**CITY OF CHESTERFIELD
PLANNING AND PUBLIC WORKS COMMITTEE MEETING**

**THURSDAY, APRIL 23, 2026
5:30 P.M.**

RE: Carshield: An Amended Site Development Plan for a 32-acre tract of land zoned "PI" Planned Industrial located east of N. Eatherton Rd.

RE: **Westland Acres 2026 SDP:** A Site Development Plan and Landscape Plan for 56.31 acres of land zoned “PUD” Planned Unit District located north of Strecker Road and east of Church Road.

Sheet Title:	Tree Stand Delineation
Sheet No:	TSD
Date:	7/31/25
Job #:	1095.001

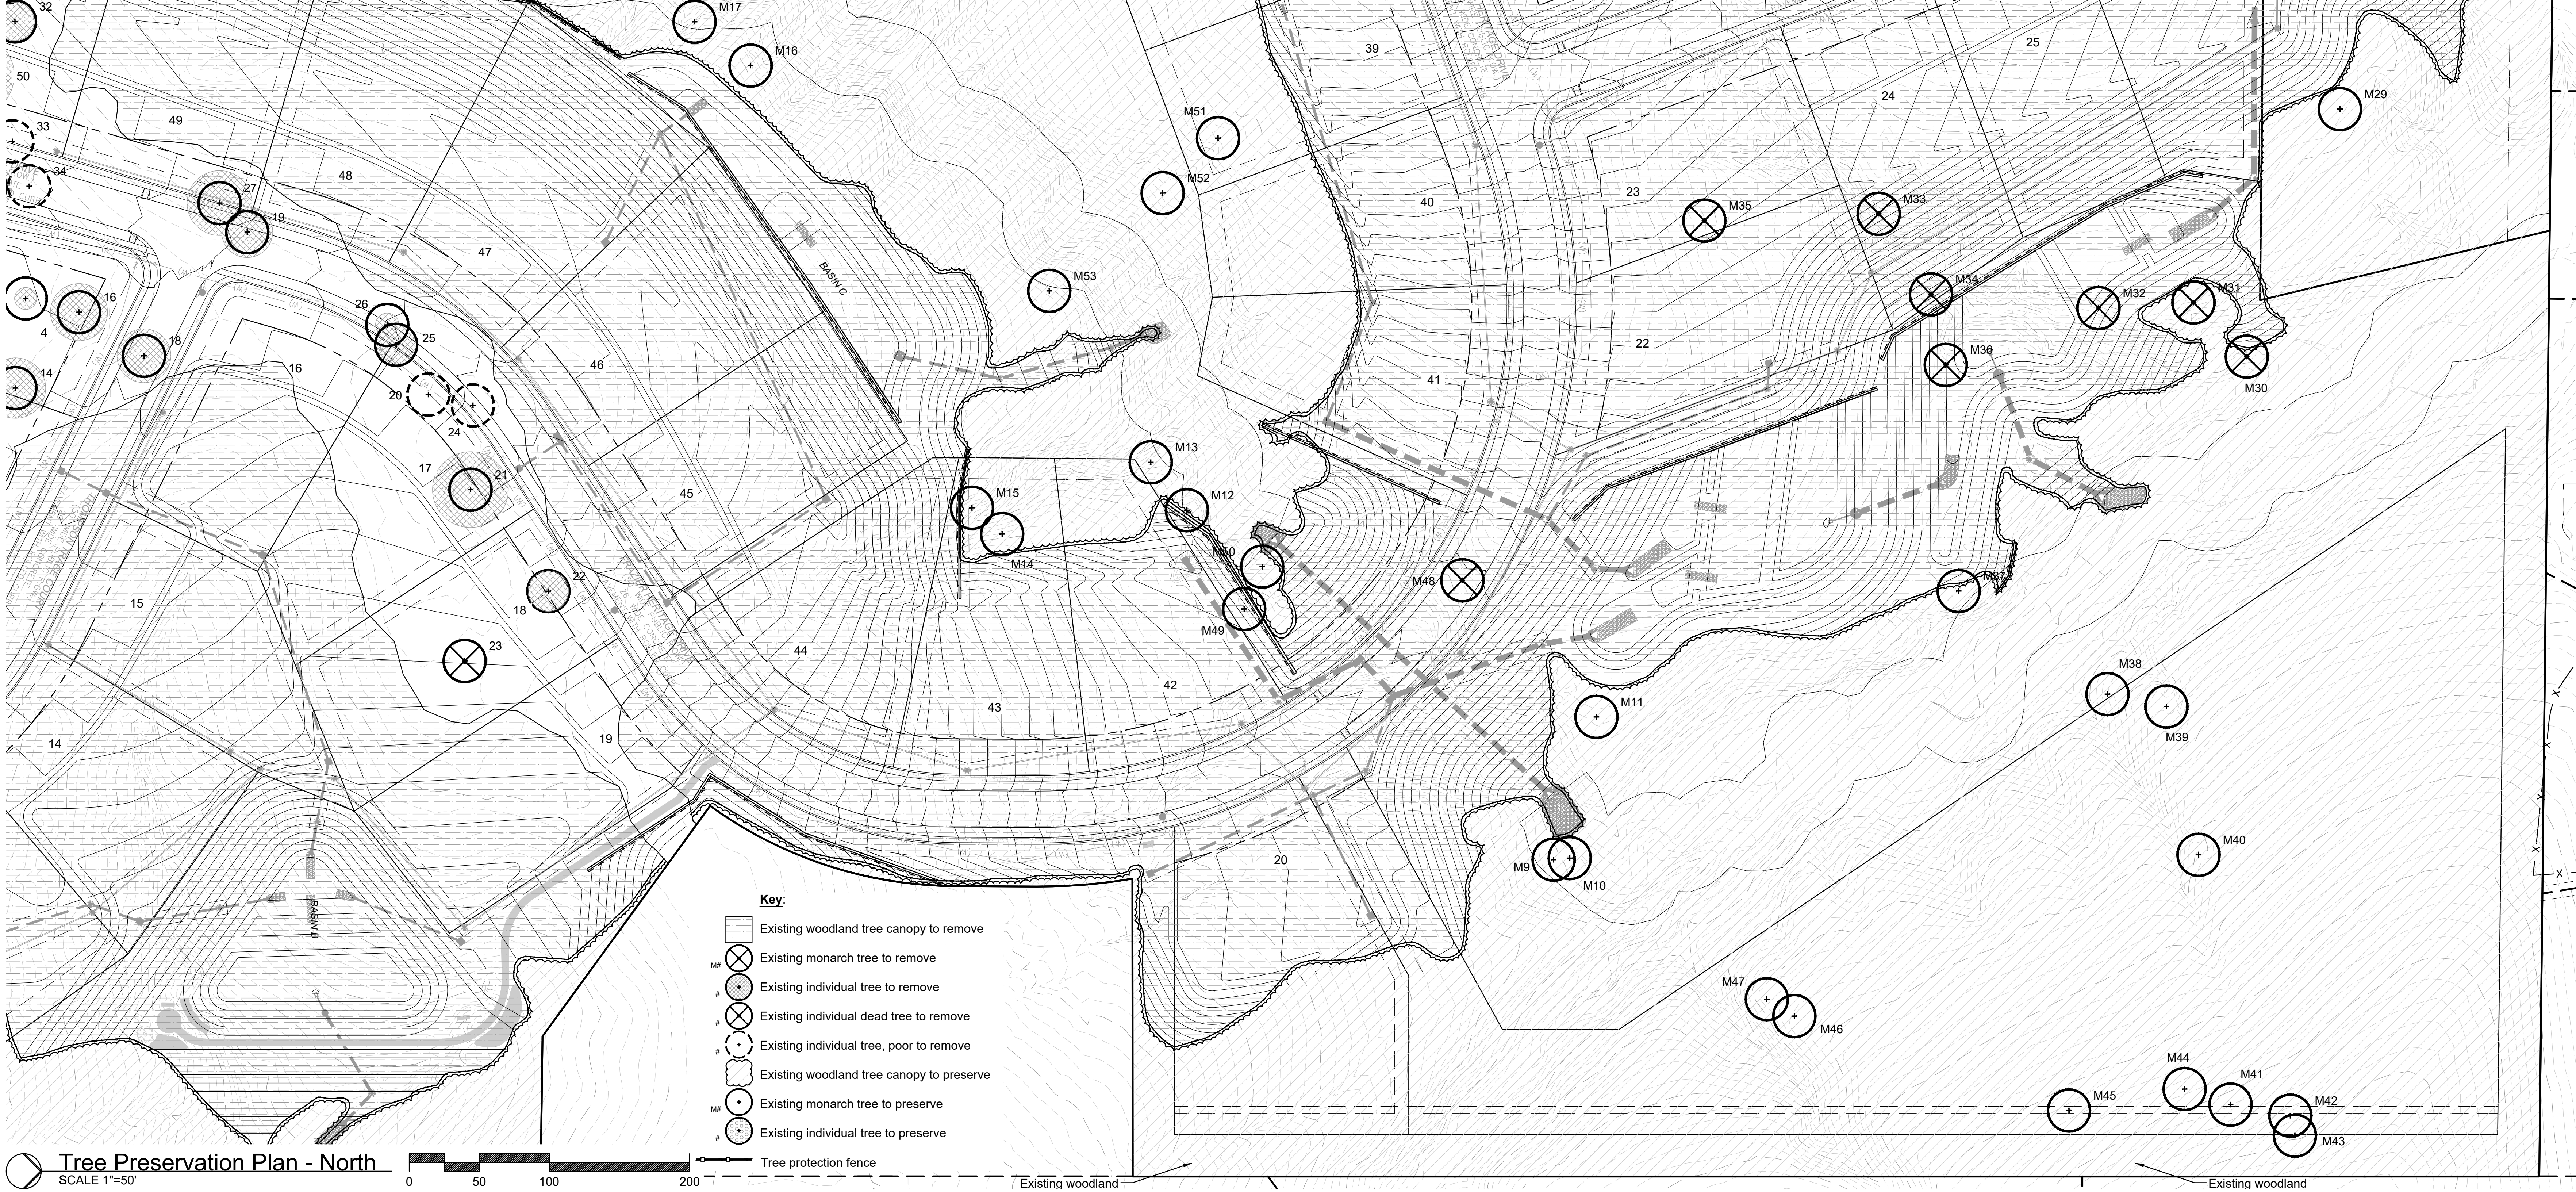
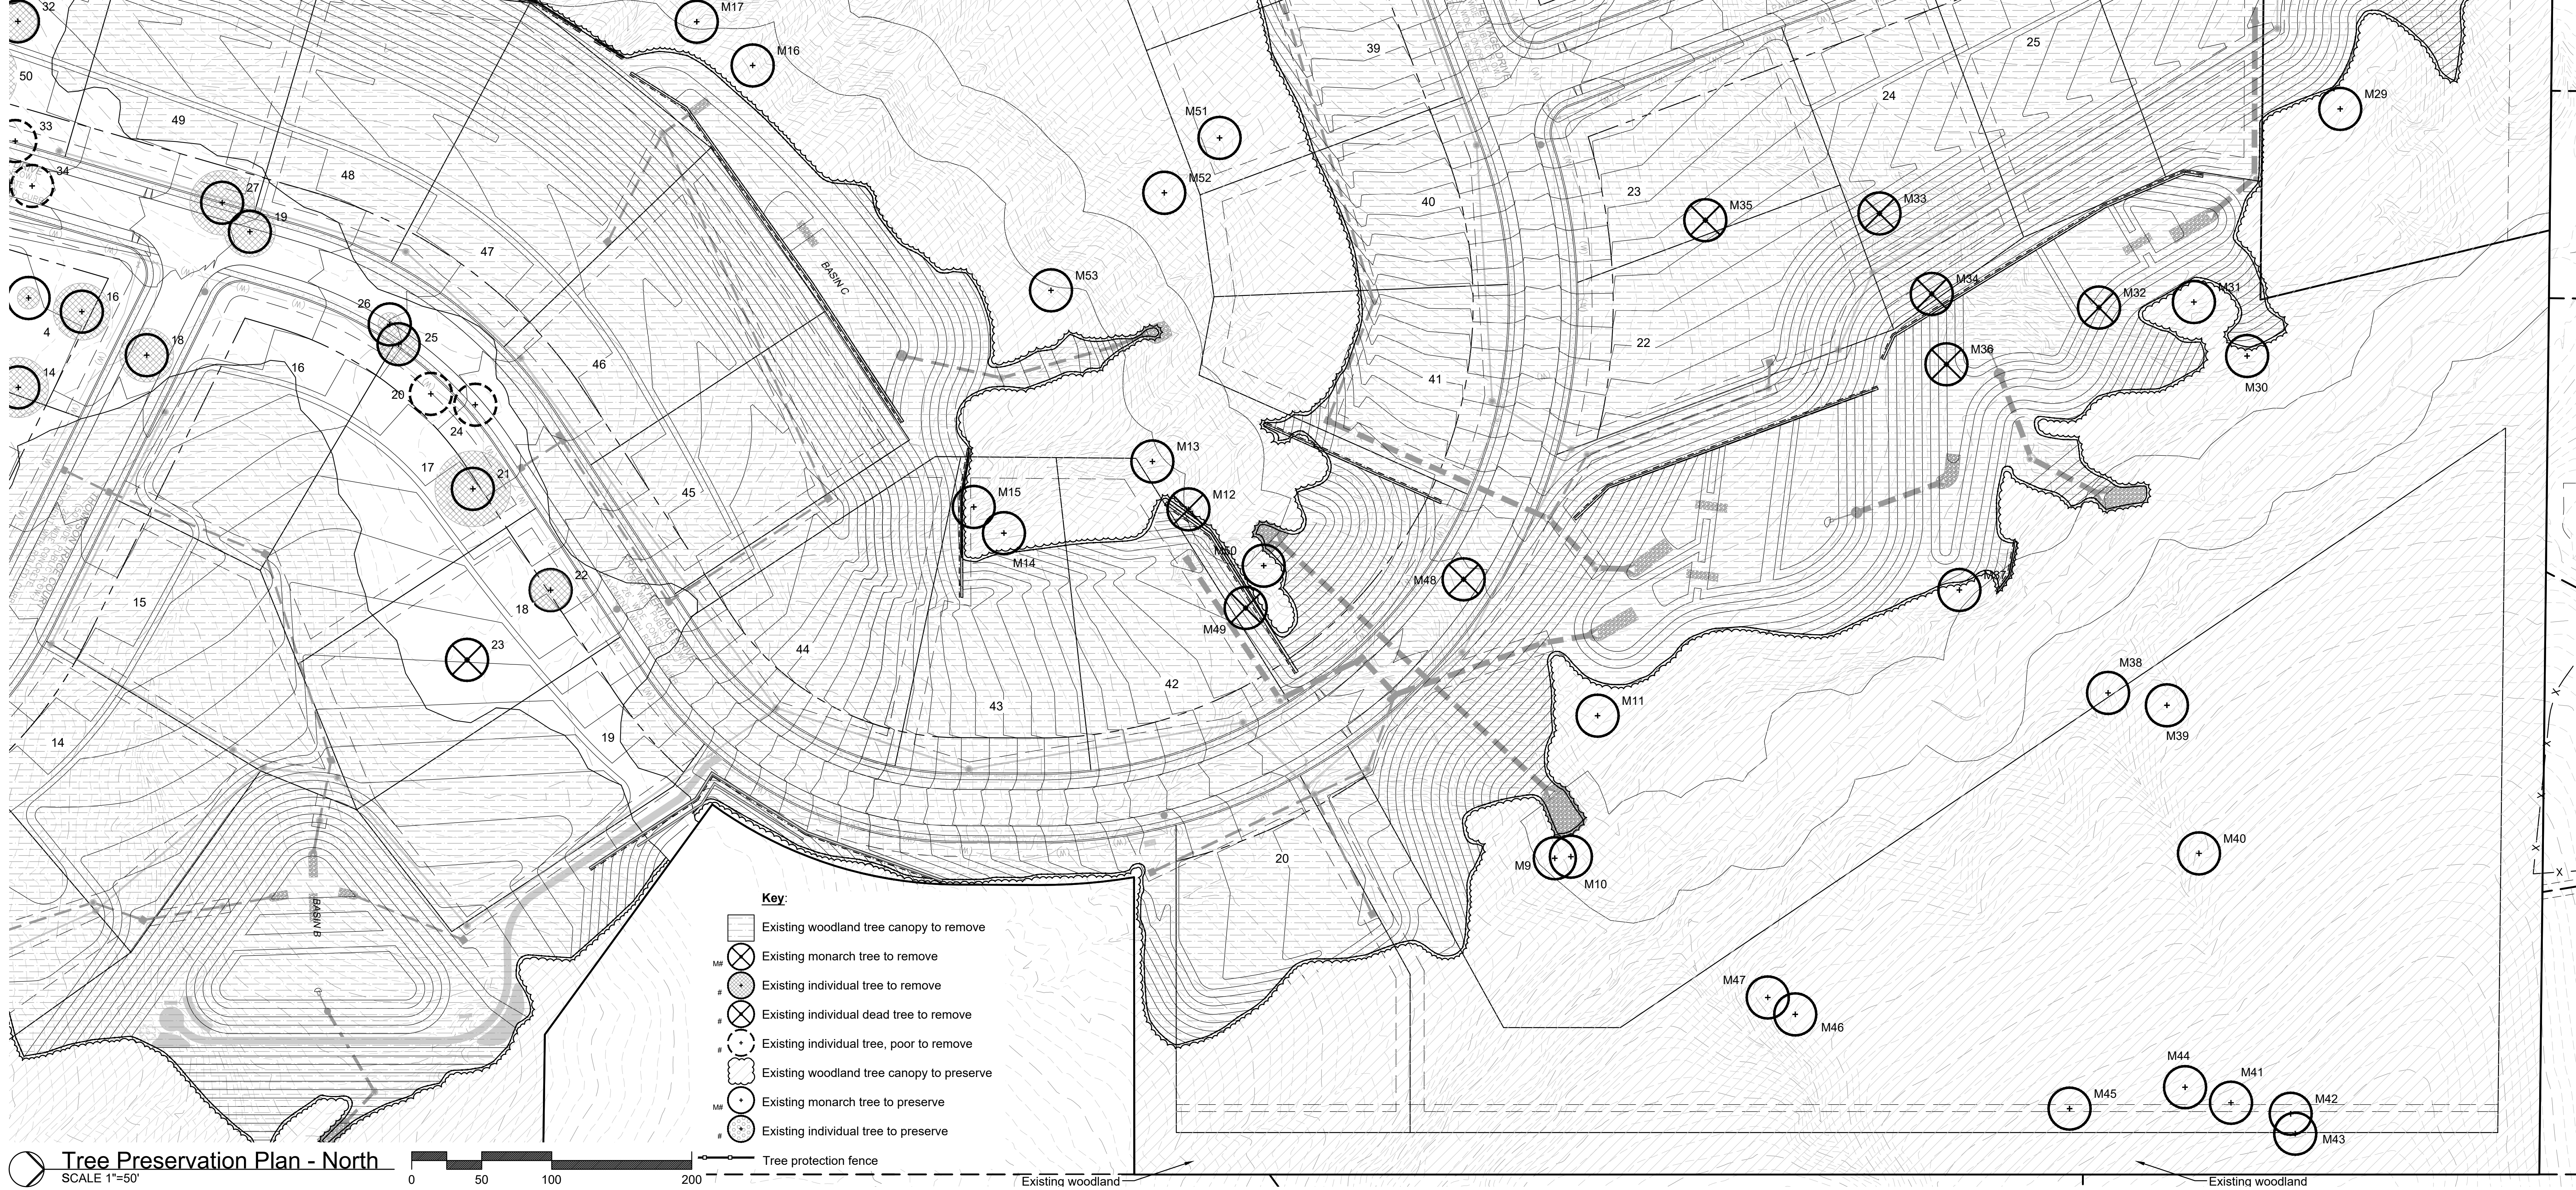
Last week, a resident contacted the City after identifying a few inconsistencies in the Tree Preservation Plan. While plans go through multiple layers of review, City staff also benefit from the perspective of surrounding residents to help ensure that as many issues as possible are identified and addressed. Once this was brought to my attention, I reached out to the developer and asked them to review and resolve the discrepancies. They have since revised the plan, and the updates are as follows:

The revised Tree Preservation Plan will be included in Staff's packet for review by the Planning and Public Works Committee. Loomis Associates Landscape Architects and Planners confirmed that the corrections maintained the overall totals (26 Monarchs preserved and 27 removed) and ensured that the discrepancies do not impact the preservation calculations.
